CALIFORNIA COASTAL COMMISSION

REGULAR CALENDAR
STAFF REPORT AND PRELIMINARY RECOMMENDATION

Application No.: 6-01-159

Description: Construction of an approximately 40 ft.-long, 13 ft.-high and 27 in.-thick tiedback concrete seawall incorporating two rows of approximately 30 ft.-long rock anchors.

PROFILE SECTION A/2

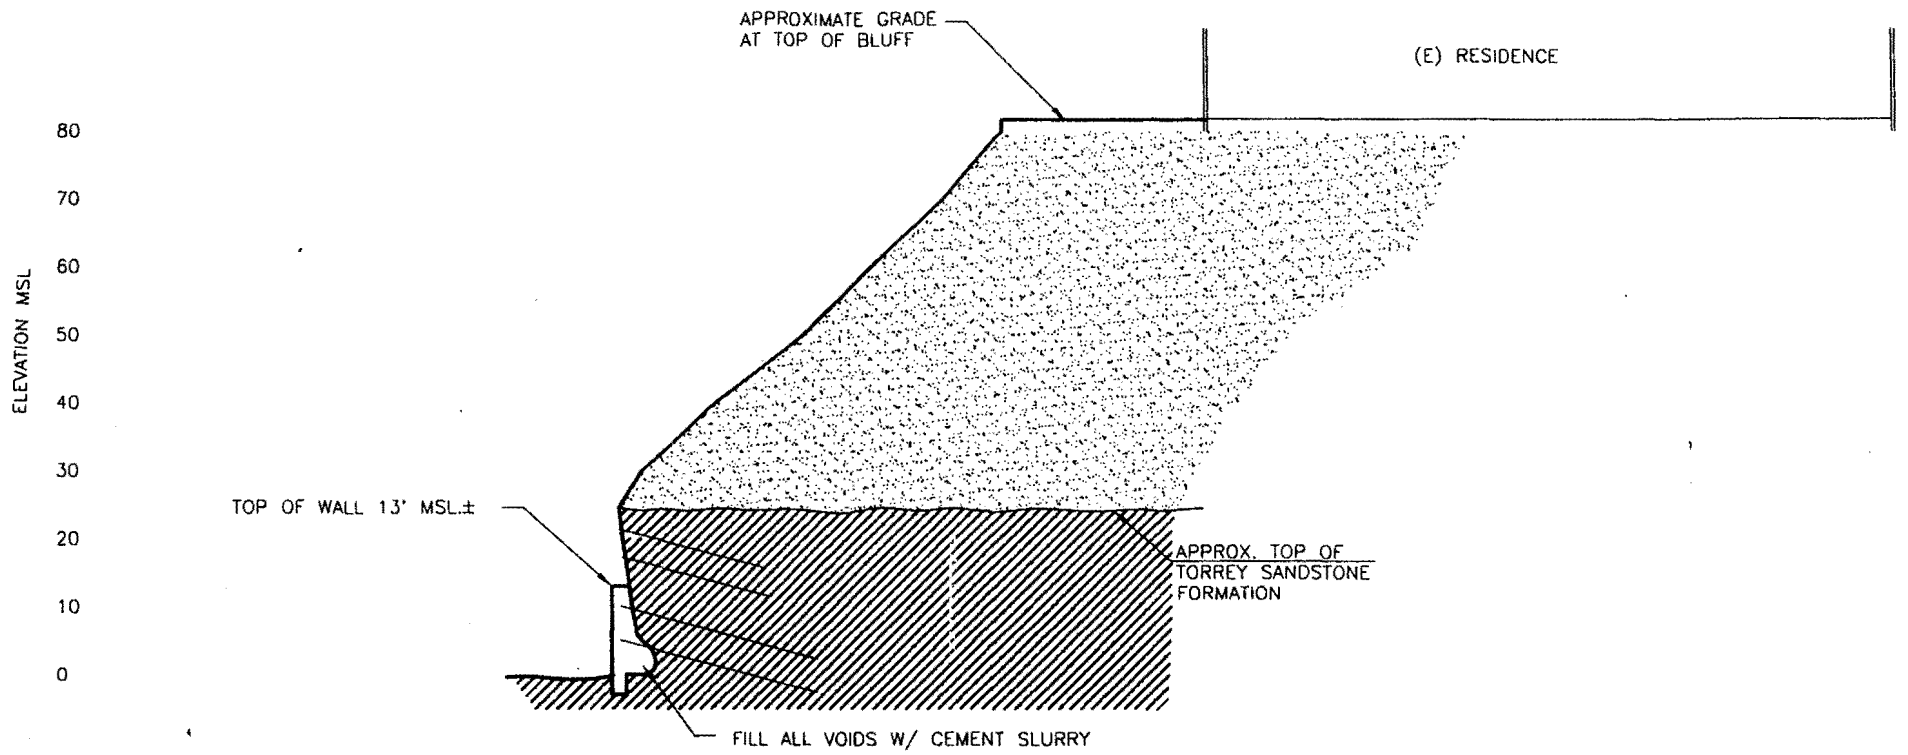
- 5) Clarification of the line of cross section in reference (4)—since both sections marked on the plan are labeled "A2," it is difficult to say with certainty which line is used for the section.

Encinitas Bluff stability:
CDP Application 6-01-053:
Analysis Method: Bishop
Slip Surface Option: Grid and Radius
P.W.P. Option: (none)
Tension Crack Option: (none)
Seismic Coefficient: (none)

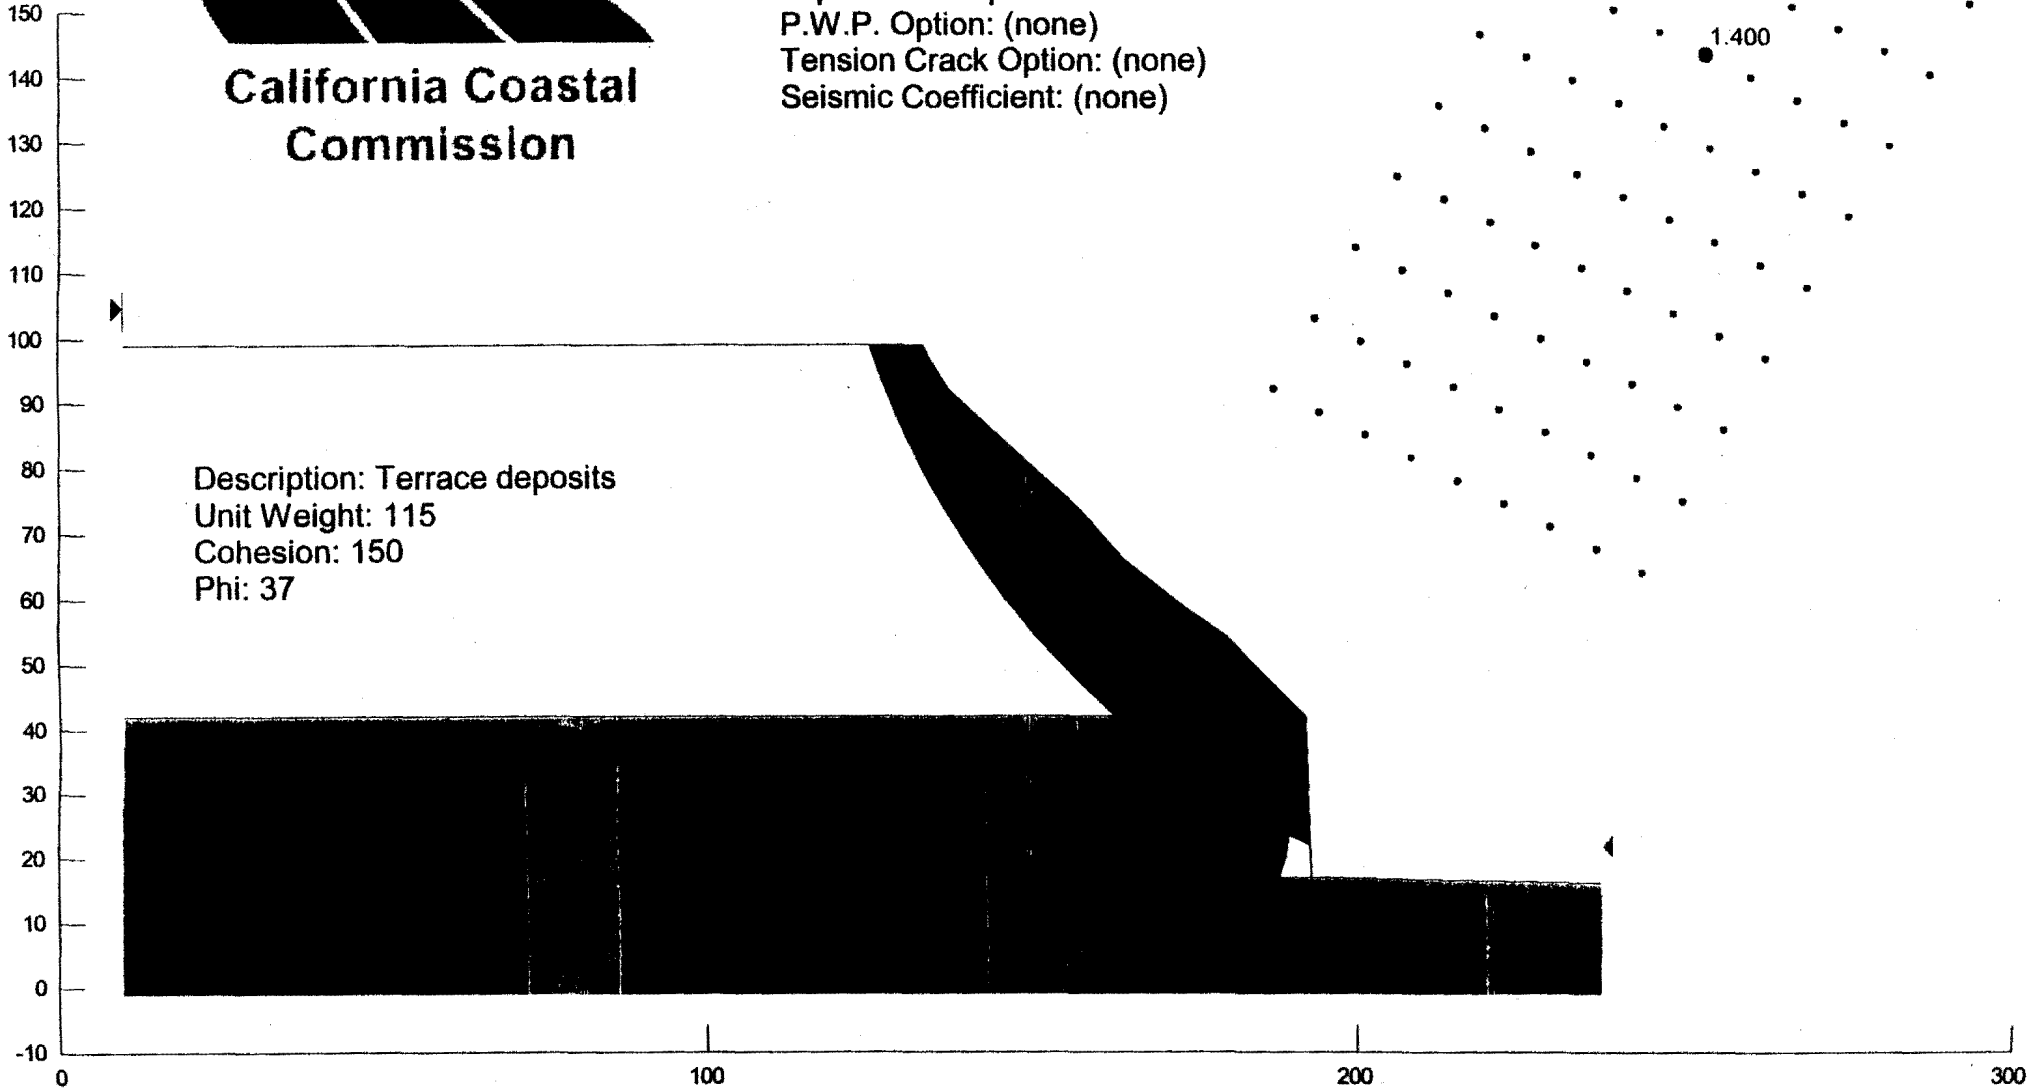
I have since modeled the stability of the bluff myself, using the more overhanging of the two bluff geometries (below 310 Neptune Avenue) as provided in figure 3 of the document referenced above. Although I used the same input parameters (unit weight, cohesion, friction

angle) and similar analysis methods as in the 17 March 2000 and 7 April 2000 Soil Engineering Construction reports, I was unable to reproduce the reported low factors of safety for the overall stability of bluff. My analysis showed a static factor of safety of 1.400 using the Bishop method, and 1.398 using the mathematically more rigorous Morgenstern-Price method (see attached figures). Although these figures are below the figure of 1.5 generally required for new construction, they do show that the bluff is not in imminent danger of failure through a mechanism involving collapse of the entire bluff along a failure plane extending uninterrupted through the Torrey sandstone and the overlying terrace deposits.
